Contract #: 04-0120F4Cty: SF/ALA Rte: 80 PM: 13.2/13.9File #: 69.25B**QUALITY ASSURANCE -- NON-CONFORMANCE REPORT****Location:** Changxing Island, Shanghai, P.R. China**Report No:** NCR-000852**Prime Contractor:** American Bridge/Fluor Enterprises, a JV**Date:** 01-Oct-2010**Submitting Contractor:** Zhenhua Port Machinery Company, Ltd (ZPMC), Changxing Island**NCR #:** ZPMC-0814**Type of problem:**

QUALITY ASSURANCE -- NON-CONFORMANCE REPORT

Subject: NCR No. ZPMC-0814

QUALITY ASSURANCE -- NON-CONFORMANCE RESOLUTION

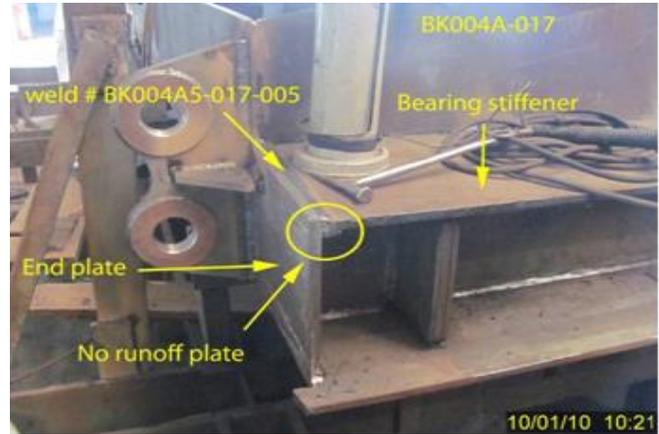
Issue 1:

- The welding has been performed without the use of runoff plates.
- The welds are Complete Joint Penetration (CJP) with steel backing joining the Bearing Plate (BKPL7A/B) and end plate (BKPL3A/B).
- The welds are identified as: BK004A5-017-005 and BK004A3-017-002.

Issue 2:

- Steel backing that was tacked on the bearing plate (horizontal plate) was not properly "placed and held in intimate contact" with the end plate.
- The maximum gap between the steel backing and end plate is over 4mm.
- The weld is Complete Joint Penetration (CJP) with steel backing joining the Bearing Plate (BKPL7B) and End Plate (BKPL3B) of bike path.
- The weld is identified as: BK004A5-017-008.

-AWS D1.5 (02) Section 3.12.1 – “Welds shall be terminated at the end of a joint in a manner that will ensure sound welds. Whenever possible, this shall be done by use of weld tabs (extension bars and runoff plates) placed in a manner that will duplicate the joint detail being welded.”

-AWS D1.5 (02) Section 3.13.5 – “Steel backing shall be placed and held in intimate contact with the base metal. The maximum gap between steel backing and the base metal at the weld root shall be 2 mm [U16 in.]”

Reference Resolution: ZPMC has discussed this issue with the Production personnel to ensure they understand the requirements of runoff tabs and backing bars.

ZPMC has discussed this issue with the Production personnel to ensure they understand the requirements of runoff tabs and backing bars. In addition, ZPMC has written an internal NCR regarding this to make this non conformance known. As this has not occurred widespread in the project, ZPMC is confident that this will non conformance will be resolved. Based on this ZPMC requests closure of this NCR.

The proposed resolution is acceptable. This NCR is closed.

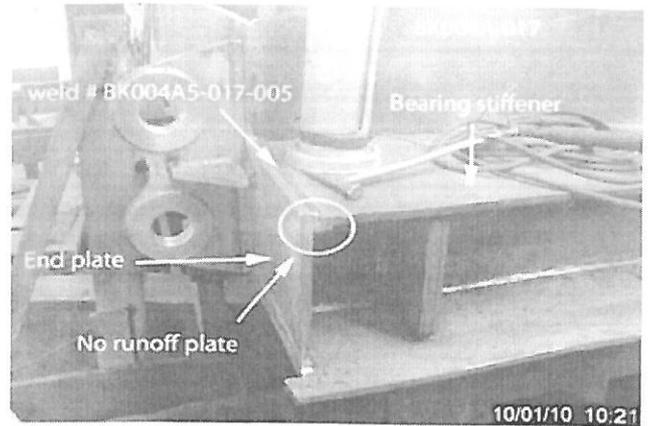
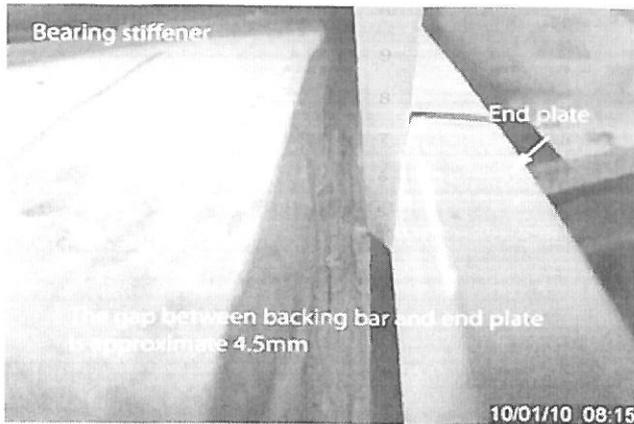
Issue 2:

-Steel backing that was tacked on the bearing plate (horizontal plate) was not properly "placed and held in intimate contact" with the end plate.

-The maximum gap between the steel backing and end plate is over 4mm.

-The weld is Complete Joint Penetration (CJP) with steel backing joining the Bearing Plate (BKPL7B) and End Plate (BKPL3B) of bike path.

-The weld is identified as: BK004A5-017-008.

-AWS D1.5 (02) Section 3.13.5 – “Steel backing shall be placed and held in intimate contact with the base metal. The maximum gap between steel backing and the base metal at the weld root shall be 2 mm [U16 in.]”

ZPMC QA personnel have talked with the floor CWI to address these problems. ZPMC is providing the NDT records to show the soundness of the affected welds in NCR. BK004A5-017-005 has been revised to be BK004A5-017-002. Based on this, ZPMC is requesting closure of this NCR.
